Addendum #1

Attn: Estimator	Date: November 14, 2024
From: Lisa Donahue, Project Administrator	Pages: 58 (including cover page)
Re: Bullock Creek School District 2024 Bond Series 1	Project: 2025 Summer Projects HS/MS/Elem/Pine River/Floyd and Maintenance Building
CC:	Proj. #: A24907

Project: No. 24-120 2023 Bond – Series 1 2025 Improvements

Issue Date: November 14, 2024

GENERAL PLUMBING NOTES

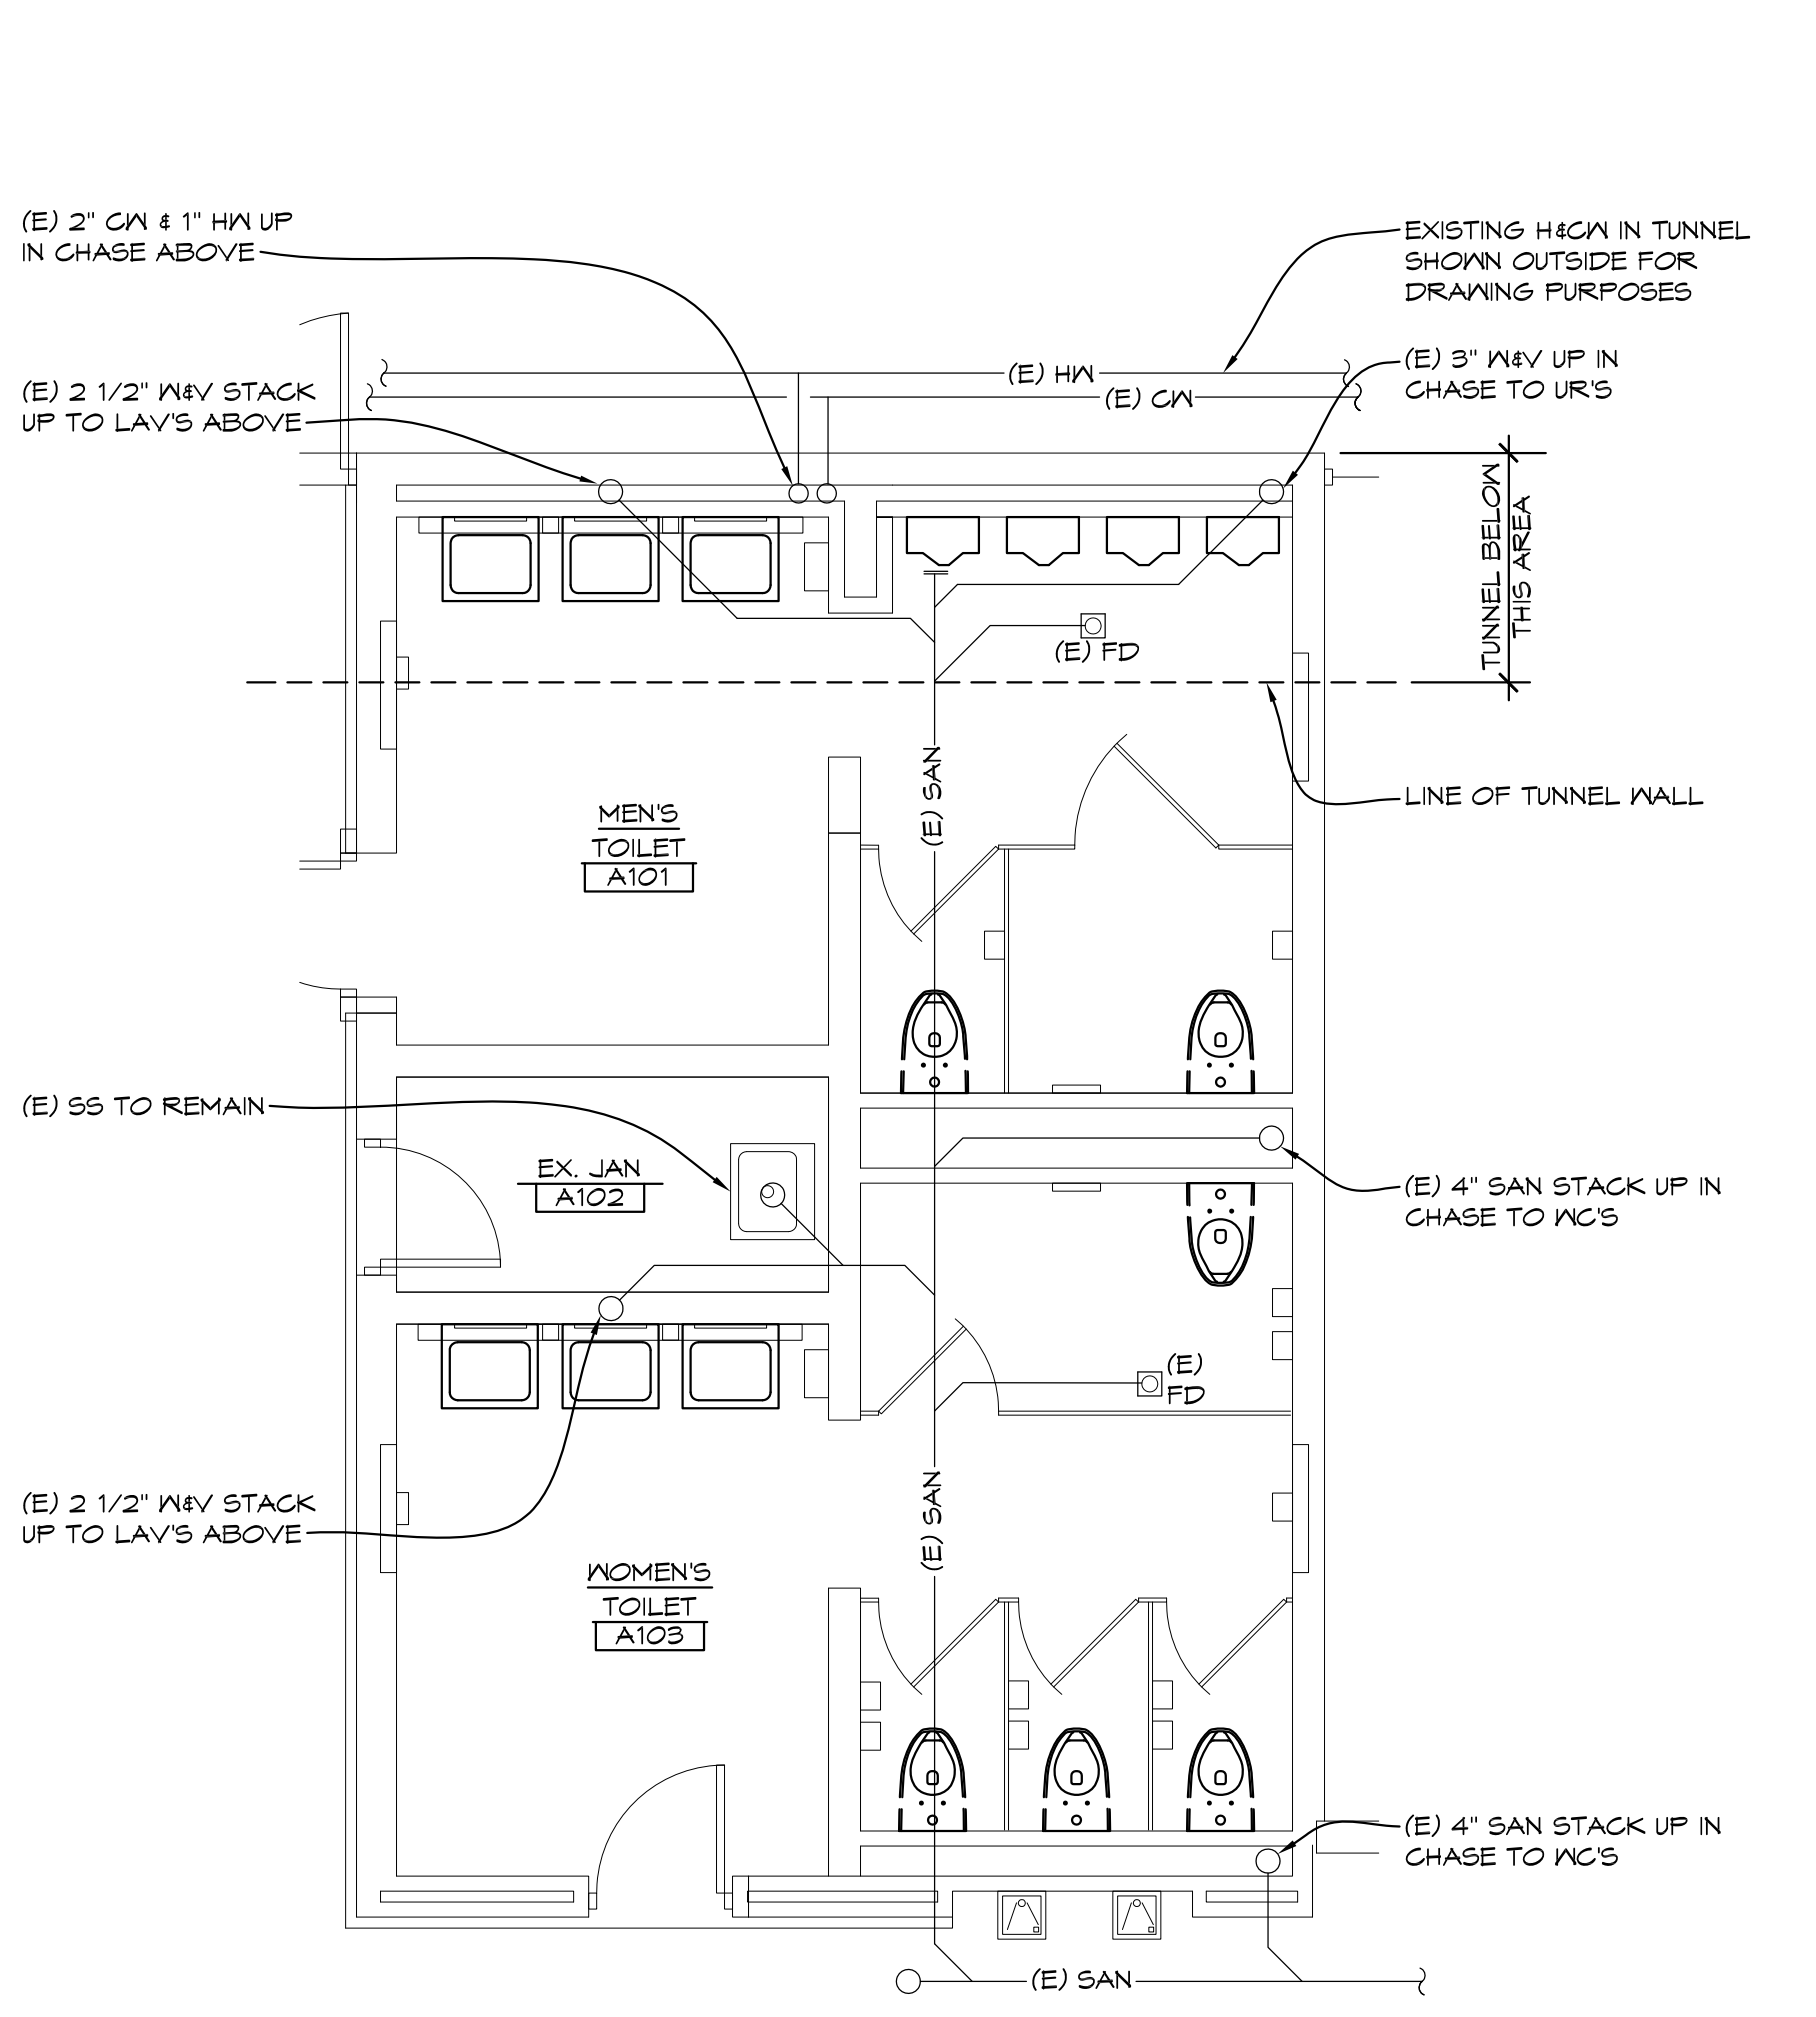
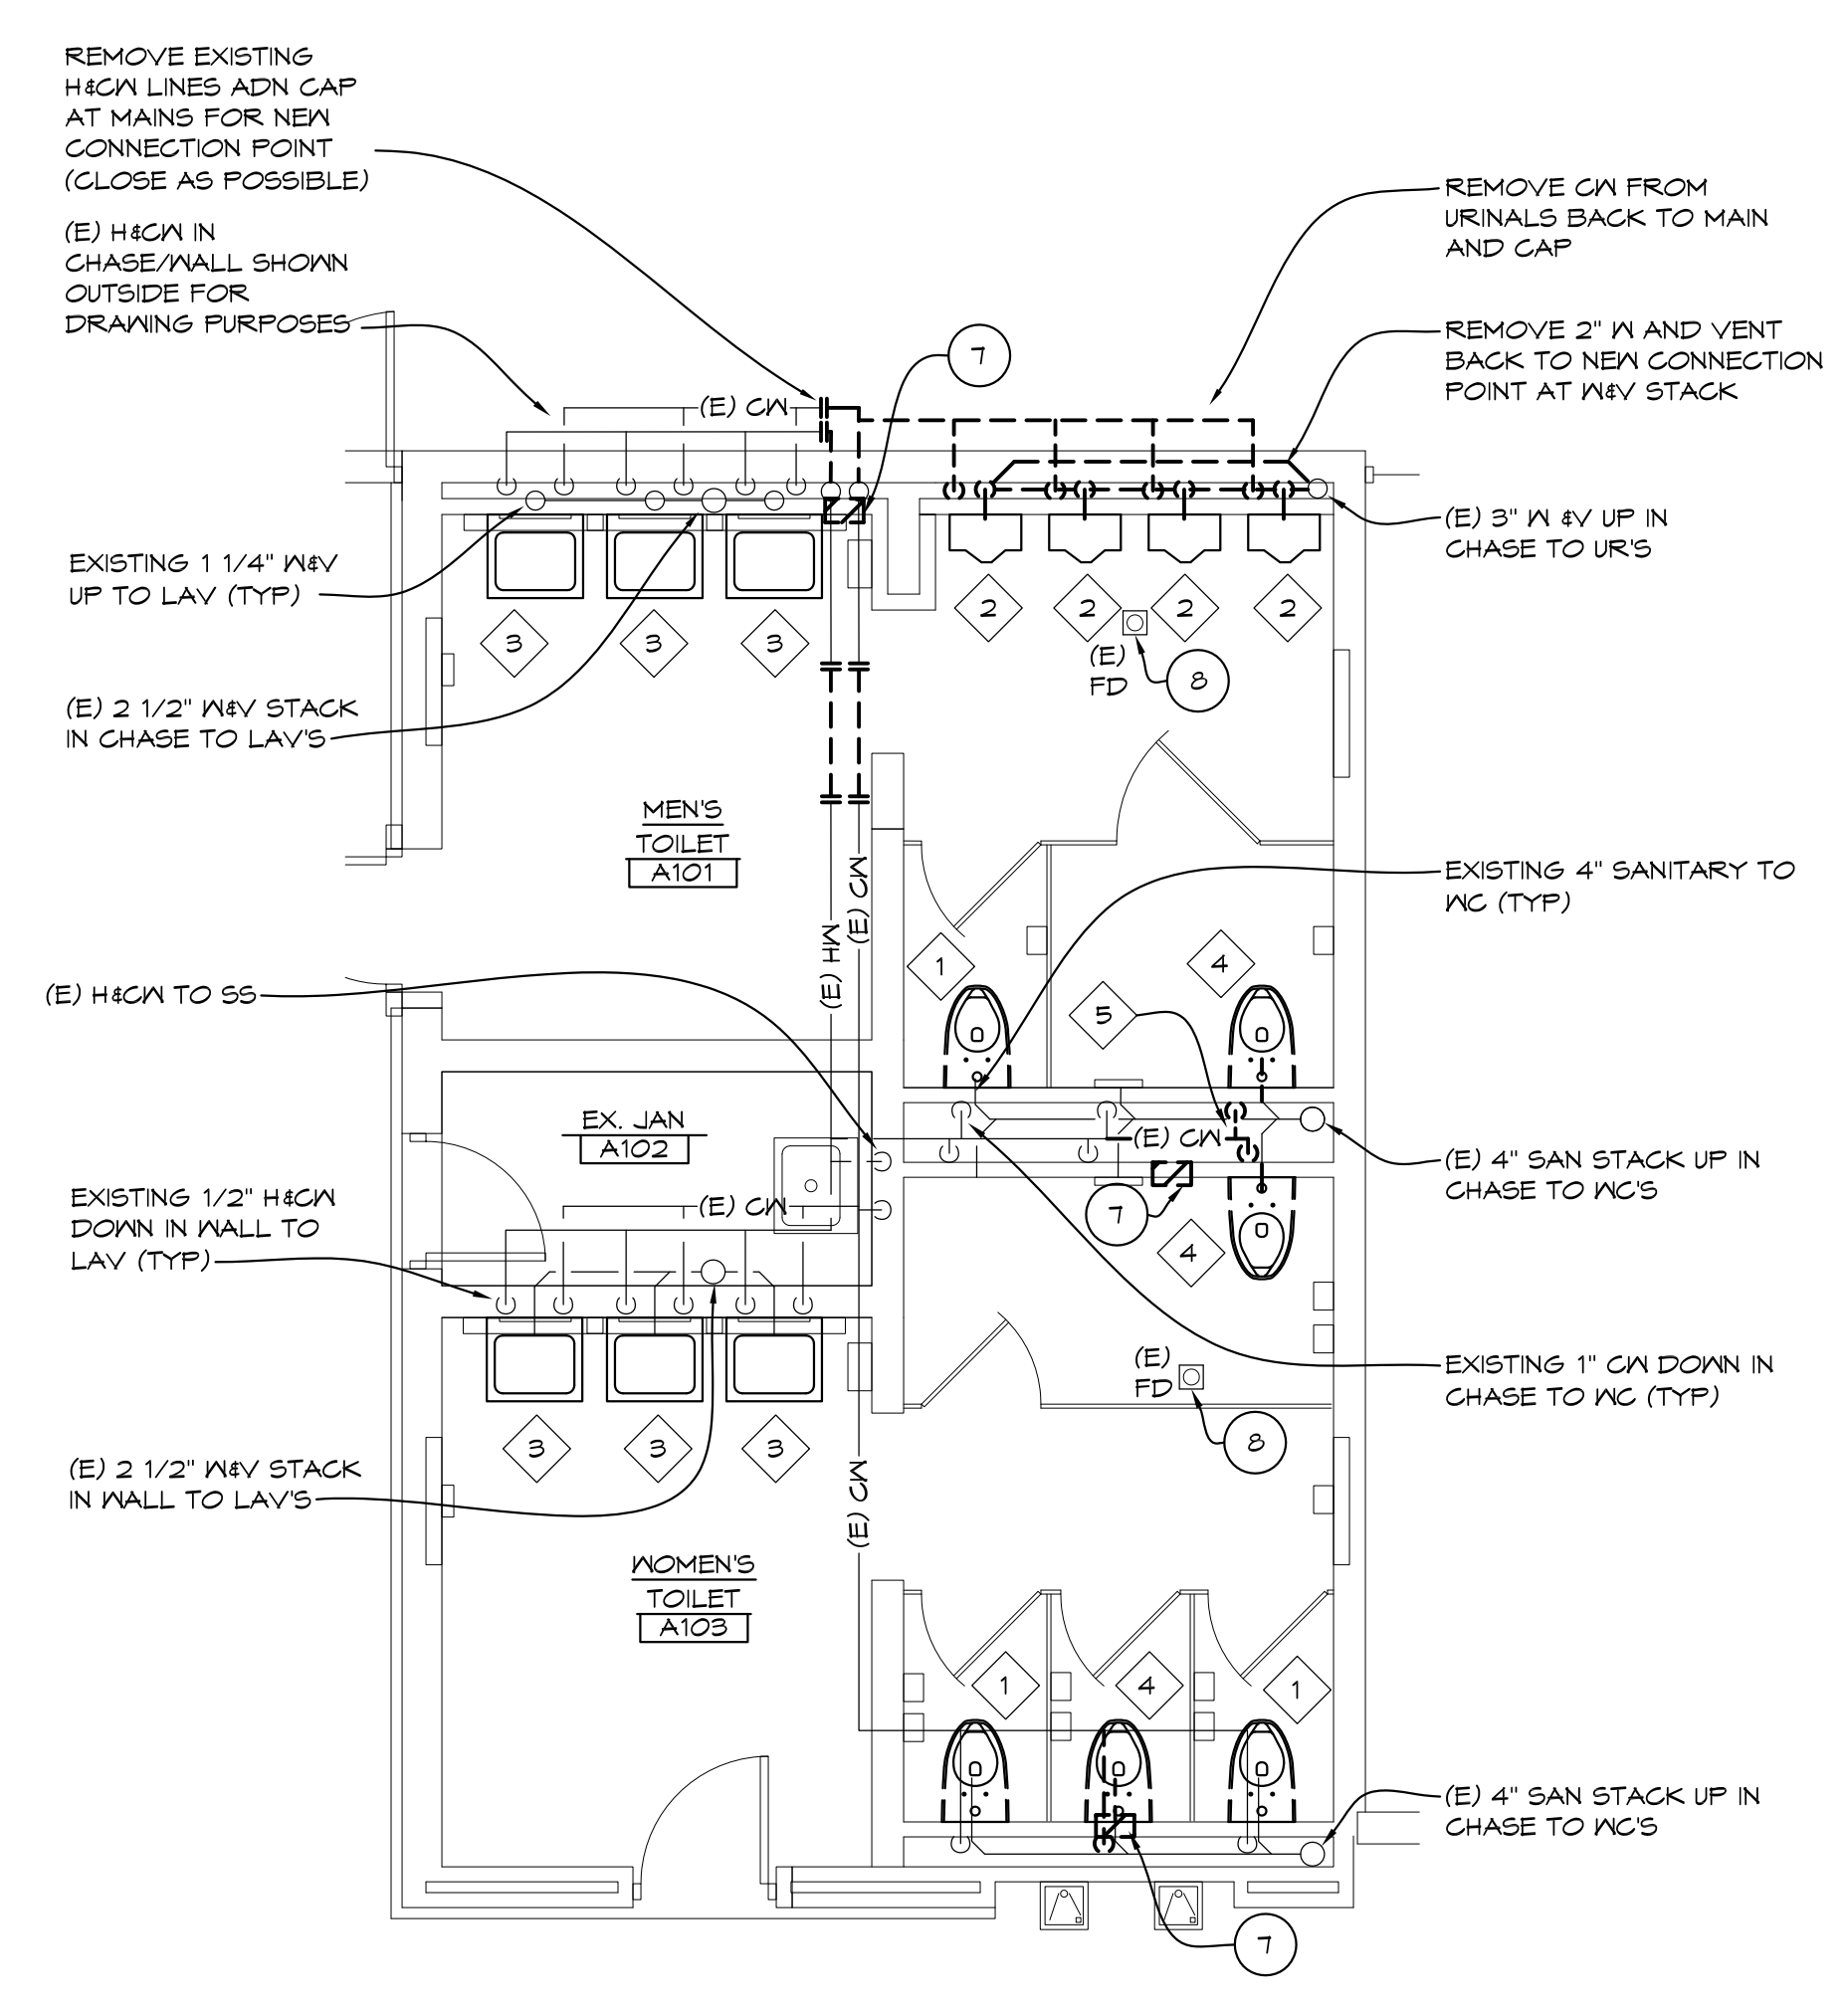
Item #P3: Revise Sheet A-P103 as follows:
a. Revise plumbing for 'D' wing toilet room D101. See piping revisions along with installation of isolation valves in ceiling space in lieu tunnel space.
b. Updated sheet count
